Project: Bayfront Parkway Corridor Improvement Project | Roundabout Peer Review Workshop
 Monday, February 22, 2021

Subject: Roundabout Peer Review Workshop | Meeting Minutes

Bayfront Parkway Roundabout Peer Review

1 REDUCE EVERY LEG TO A SINGLE LANE

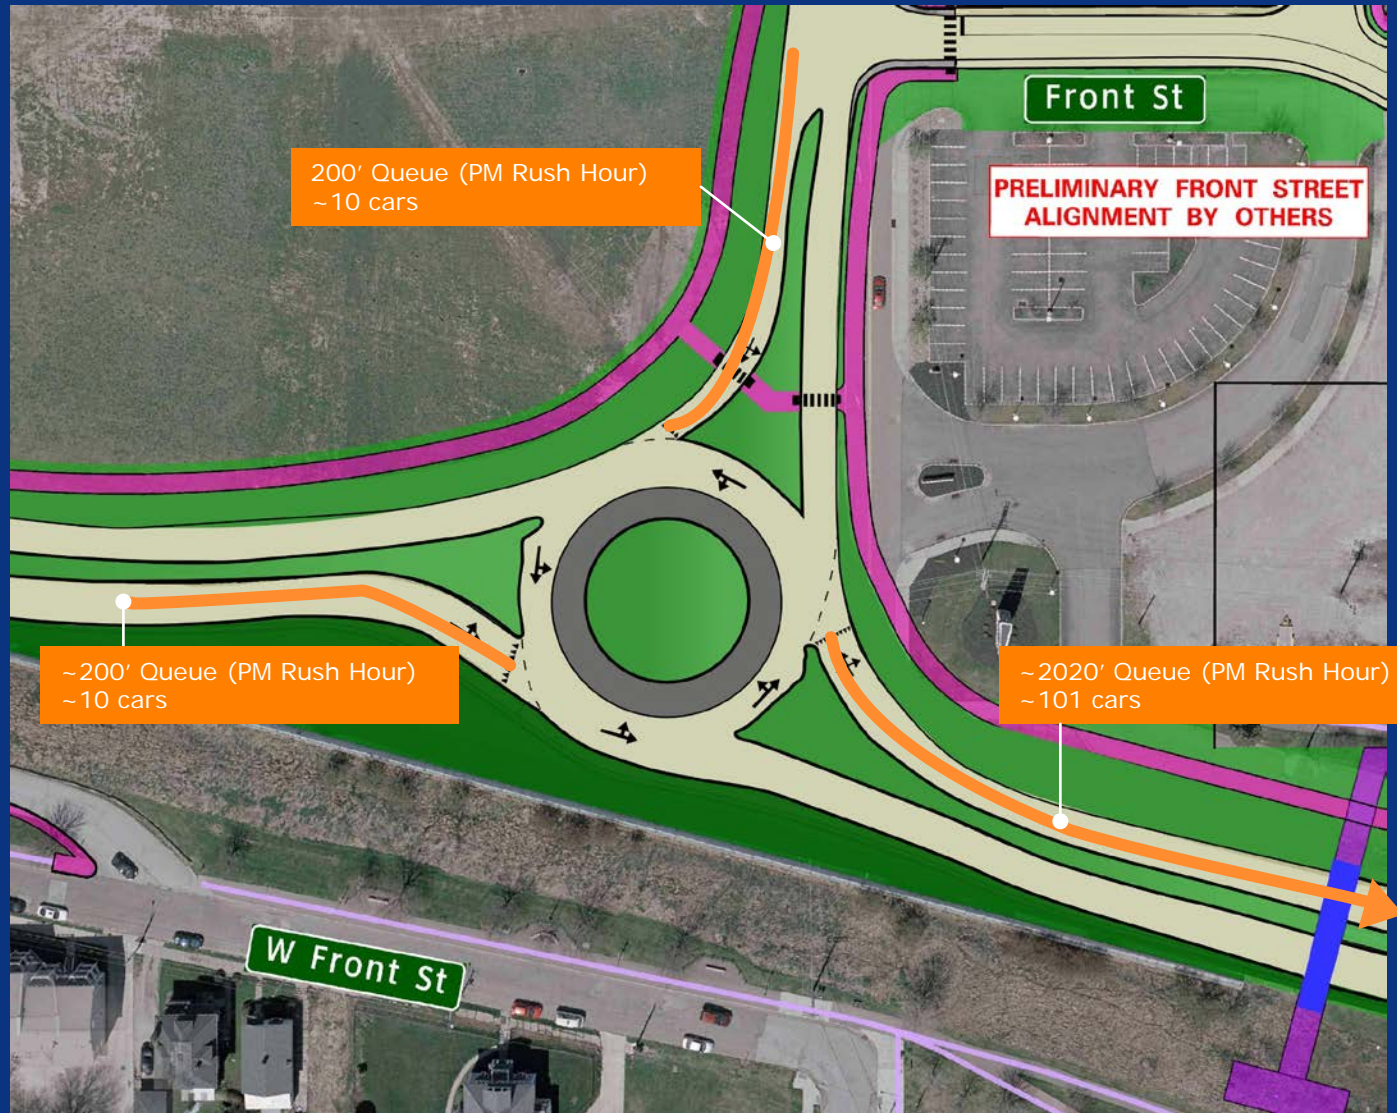
Scenario 1 : Reduce Every Leg to a Single Lane

Delay (seconds)	150
Volume-to-Capacity*	1.47

* Volume to capacity ratio should be less than 0.95

2 REDUCE SASSAFRAS ST TO ONE LANE

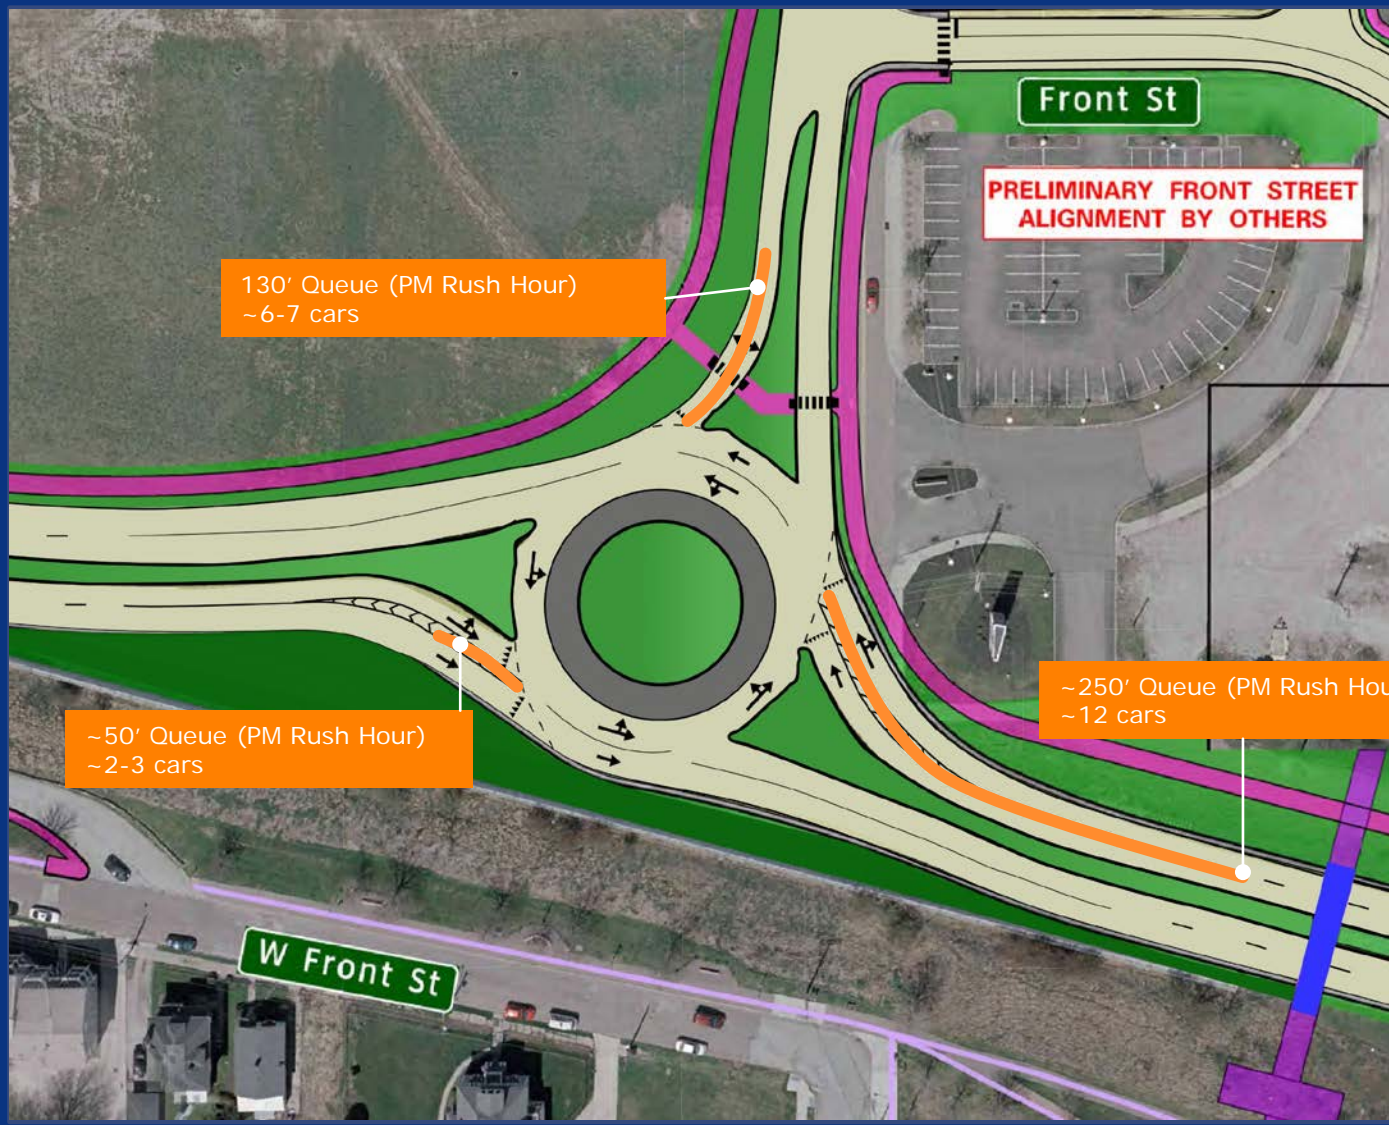
Scenario 2: Reduce SassafRAS St to One Lane

Delay (seconds)	15
Volume-to-Capacity*	0.81

* Volume to capacity ratio should be less than 0.95

3 CURRENT PENNDOT DESIGN

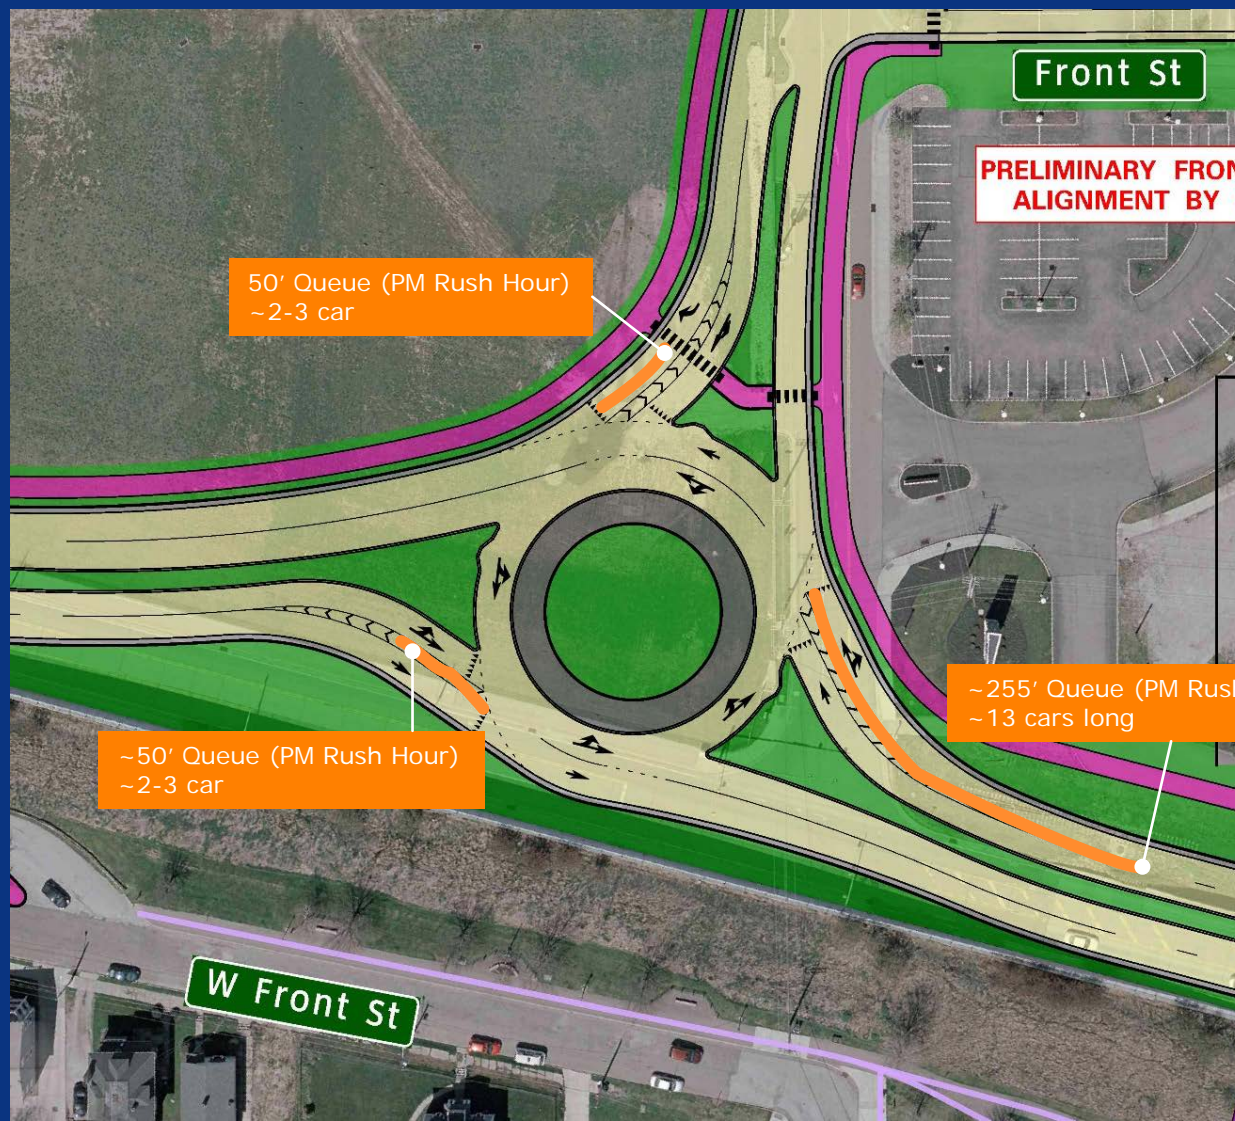
Scenario 3: Current PennDOT Design

Delay (seconds)	13
Volume-to-Capacity*	0.82

* Volume to capacity ratio should be less than 0.95

COMPARISON – SCENARIO 2 VS SCENARIO 3

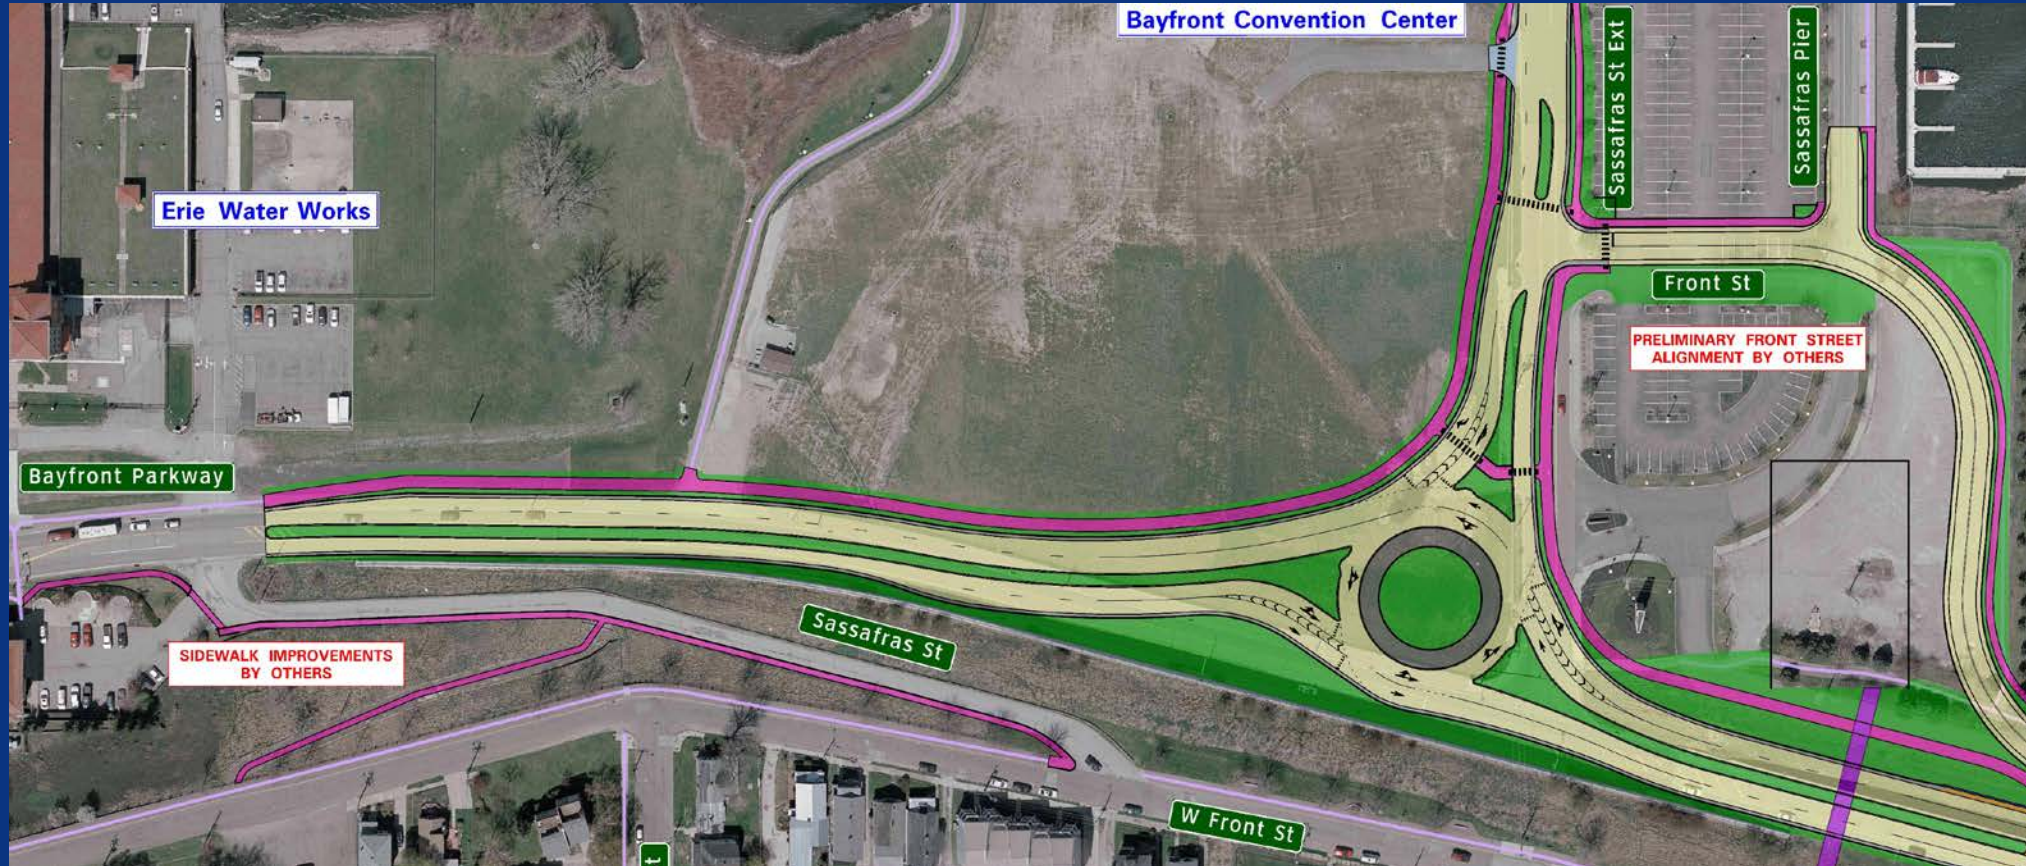
Scenario #2 Single Lane on SassafRAS St	Scenario #3 Current PennDOT Design
Intersection Control Delay (seconds)	15	13
Max Volume to Capacity	0.81	0.82

BAYFRONT PARKWAY AND SASSAFRAS STREET

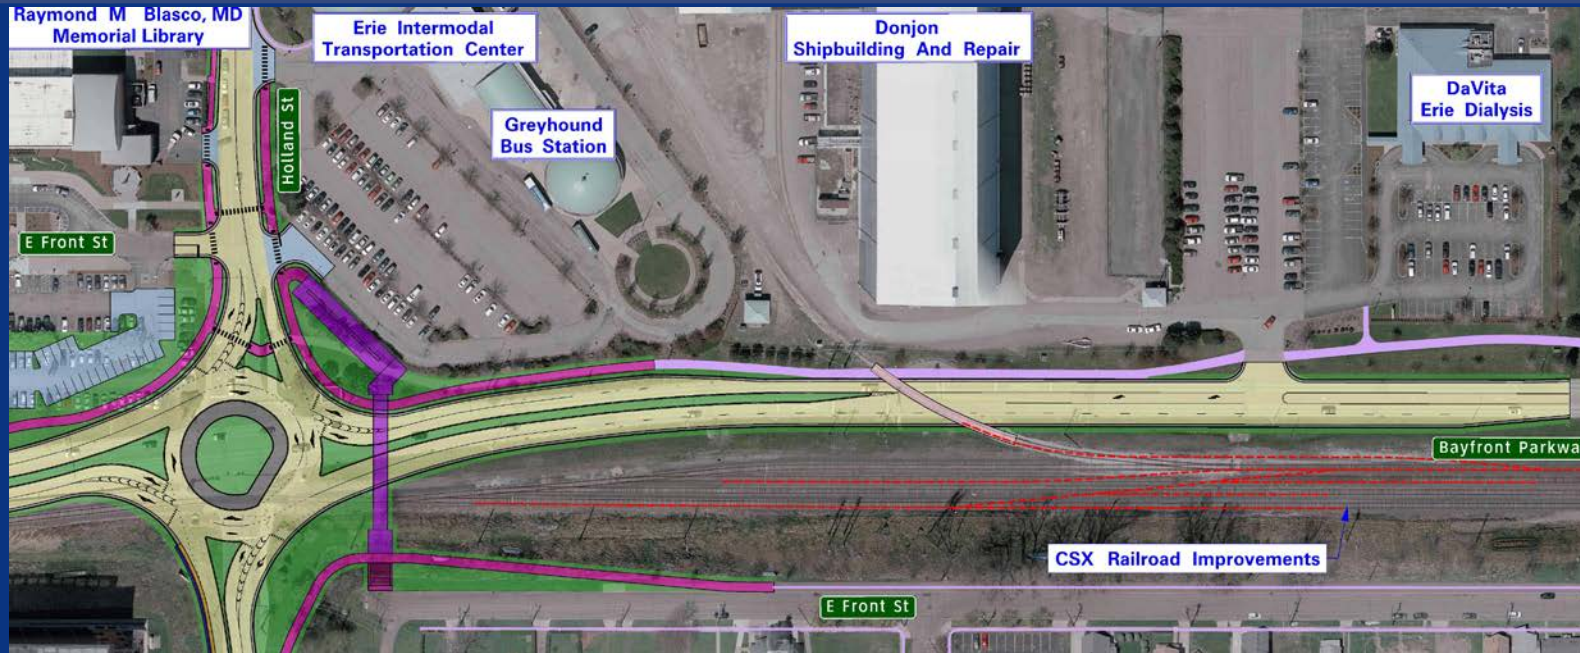
- **Peer Review Recommendation →
Sassafras Street Roundabout**

- Simplifies roundabout
- Reduces pedestrian crossing distance on Sassafras (35' → 18')
- Provides ample capacity through 2040

- We recommend Scenario 2 over Scenario 3 (current PennDOT design)
 - Eliminate One (1) Lane on Sassafras Street
 - Acquire right-of-way for future 2nd lane on Sassafras Street
 - Bayfront Parkway remains as previously proposed

1 REDUCE EVERY LEG TO A SINGLE LANE

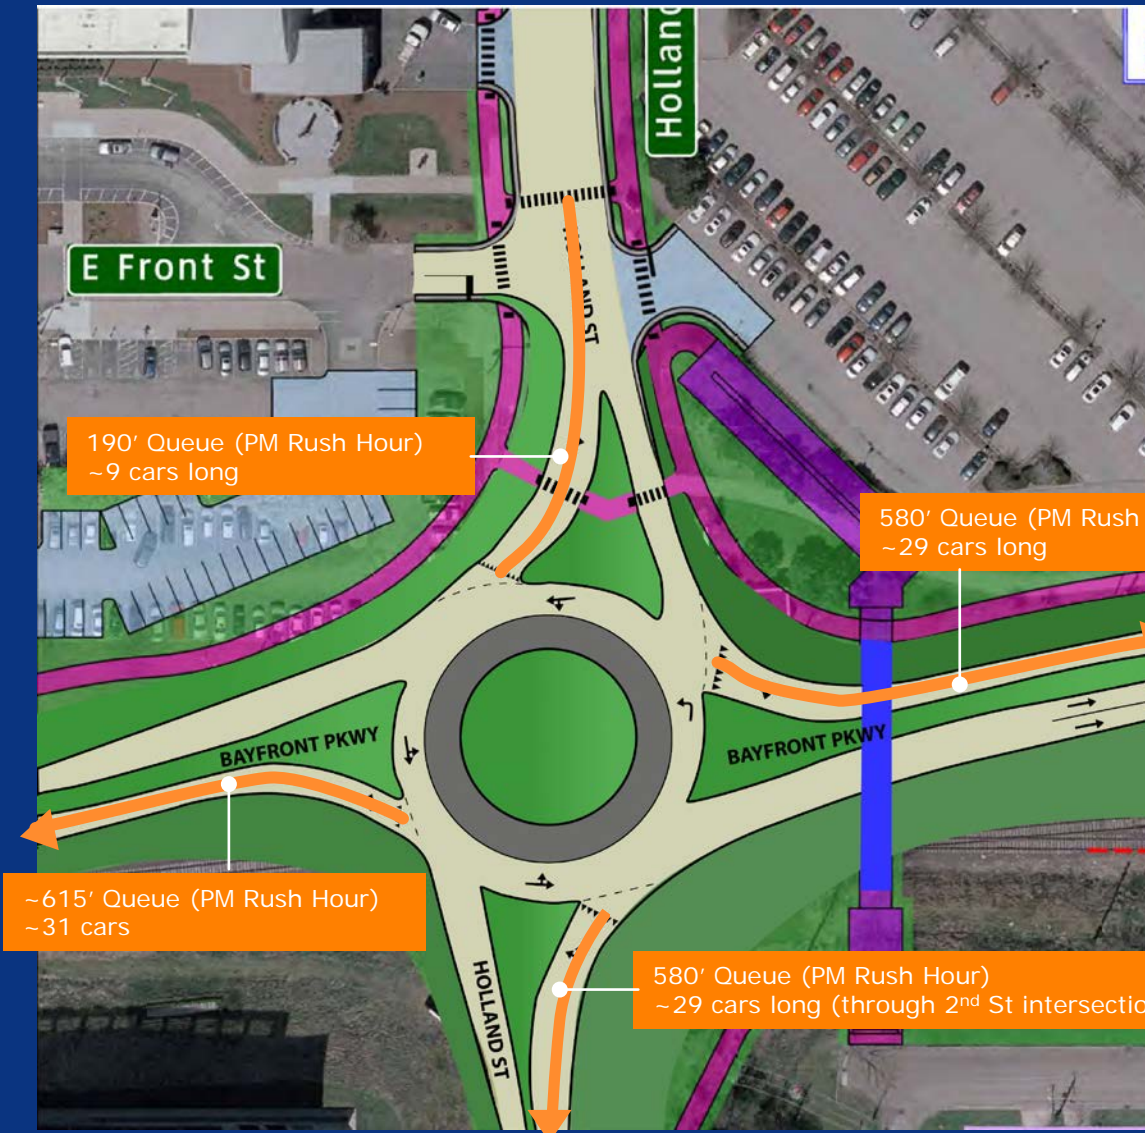
Scenario 1 : Reduce Every Leg to a Single Lane

Delay (seconds)	85
Volume-to-Capacity*	1.25

* Volume to capacity should be less than 0.95

2 REDUCE HOLLAND ST APPROACHES TO ONE LANE

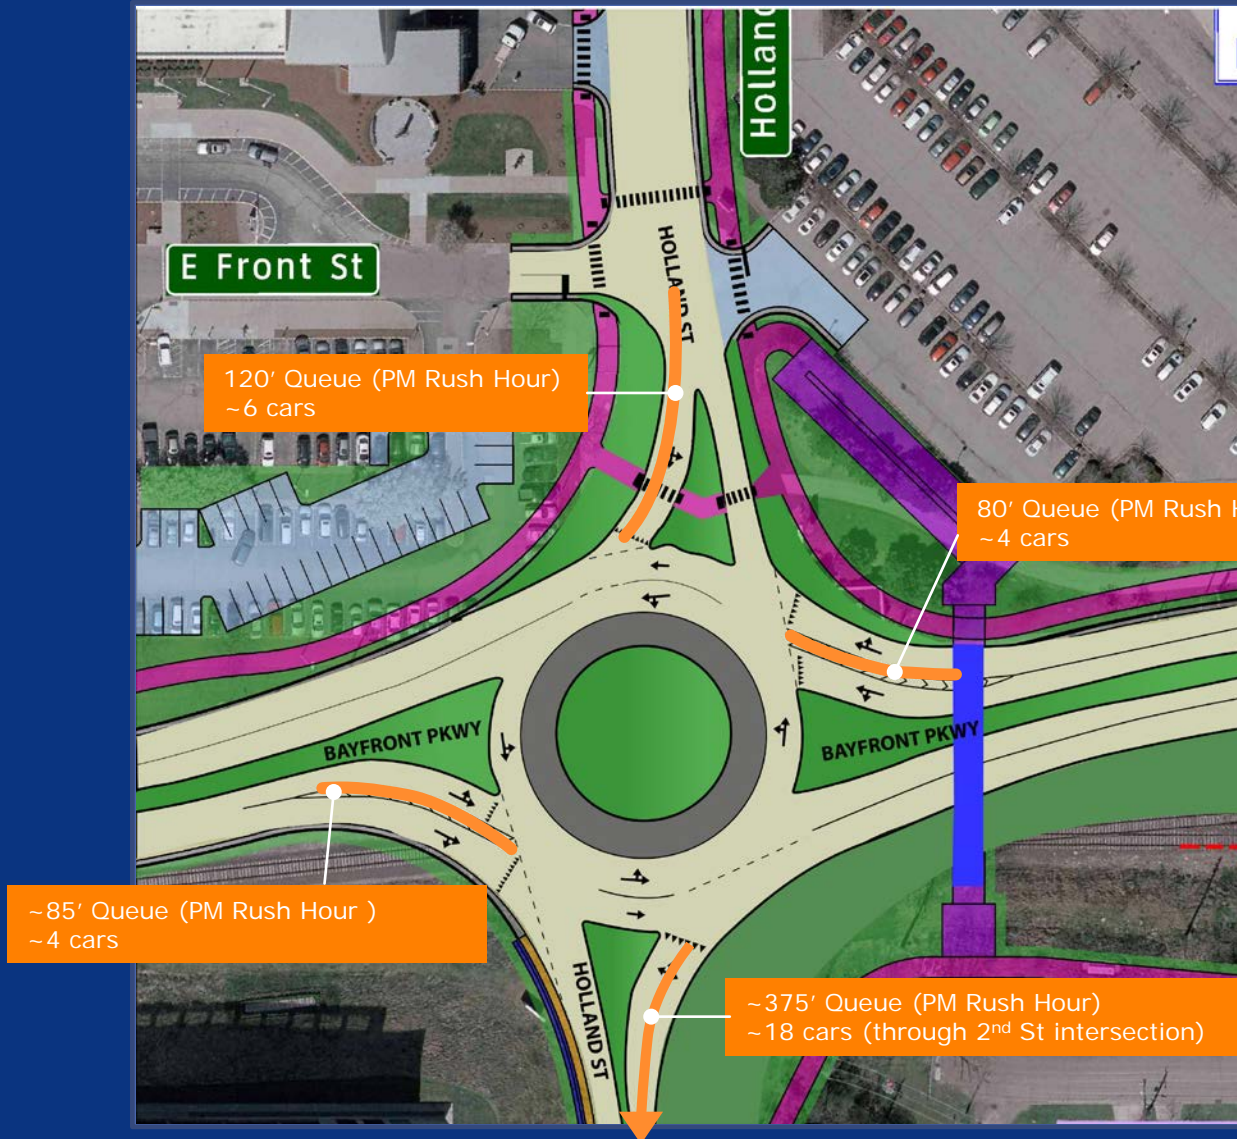
Scenario 2 : Reduce Holland St Approaches to One Lane

Delay (seconds)	23
Volume-to-Capacity*	1.01

* Volume to capacity should be less than 0.95
